# Rezoning Petition 2024-088 Pre-Hearing Staff Analysis November 18, 2024

#### REQUEST Current Zoning: O-15(CD) (office, conditional) Proposed Zoning: RAC(EX) (regional activity center, exception) Approximately 15.98 acres located along the north side of Rexford Road, LOCATION south of Wickersham Road, and west of Colony Road. Rd 2024-088 à S Clarendon Rd Downsr cough Rd MerrifieldF Inside City Limits Rd verness Rd do Cloverfield Sontiret Parcel $\tilde{O}$ Anningck'r Withersham Rd Streams Charlotte Tower Ct Glen FEMA Flood Plain Rorsin Inman Rd olony Rd Barclay **City Council District** SayreRd Ro Coca-Cola Plaza 000 6-Tariq Bokhari Trianon-Con Rexford-Rd-Sharon Townshiptn Downs Dr Toxborough Parkway Dr soyd Church Rd Sec. South Park Dr Ś ngress Carnegie By Colony Rd 0.13 0.25 Miles 0 The patition propagas a mixed use development including multi family, office SUMMADY OF DETITION

#### • Proposed Request Details

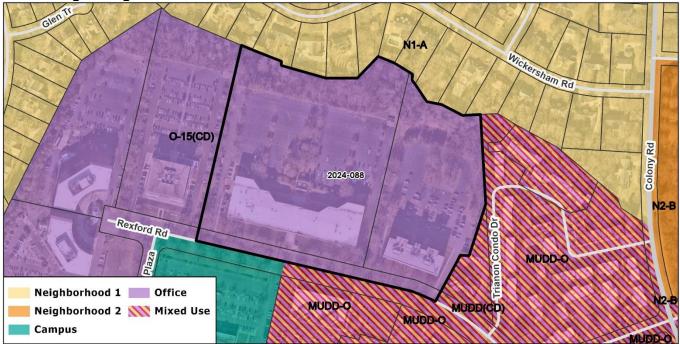
- 1. CDOT: Rexford Road: The future back of curb location is 20.5' from road centerline. CLDSM U-05A1 Local / Office Commercial Wide Street Typical Section (8' Sidewalk). Label and dimension the curb and gutter from the centerline for each road on the site plan.

- CDOT: Revise site plan to utilize commercial / office wide street sections for the public roads. Per UDO article 33, all non-residential development within the Regional Activity Center place type must utilize office / commercial wide street sections. Please revise street section shown below and update plans to reflect CLDSM U-05A1. CDOT does not accept residential wide street sections as part of the requested exception.

- 3. CDOT: Revise site plan to remove parking from driveway stems. Per Charlotte Streets Manual, a 100' minimum length is required for channelization.
- 4. CDOT: Revise site plan to include necessary ADA on-street parking spaces. Per PROWAG R211, 4 accessible spaces are required per 76-100 on-street parking spaces.

- 5. CDOT: Revise site plan revisions to remove all unsignalized crosswalks from plans. Discussion regarding crosswalks can take place during project permitting.

- 6. CDOT: Request site plan revisions to commit to installing 8' planting strip and 12' shared use path along Rexford Road as part of The LOOP. Specifications for materials to be provided during permitting.

- CDOT: Request site plan revisions to include pedestrian crossing and refuge at the midpoint between intersection to the east and existing pedestrian ramps to the west.

- Entitlement Services: the number of public benefits such as sustainability, public amenity, and city improvements should be increased to better match the number and scope of the requested exception (EX) provisions.
- 9. Entitlement Services: remove language regarding substitution of public benefits during permitting.
- 10. Entitlement Services: the scale of the proposed open space public benefit should be increased to better match the scope of the proposed EX provisions and the size of the site.
- 11. Entitlement Services: the percentage of ground floor activation should be increased beyond the proposed 30% where feasible as requested by EX provision V.
- 12. Entitlement Services: the conversion of all 200,000 square feet office proposed for Block 1 is too much. A mix of uses should be maintained in Block 1 if the office use is converted to residential.

13. Entitlement Services: the NGBS initialism should be spelled out a "National Green Building Standards."
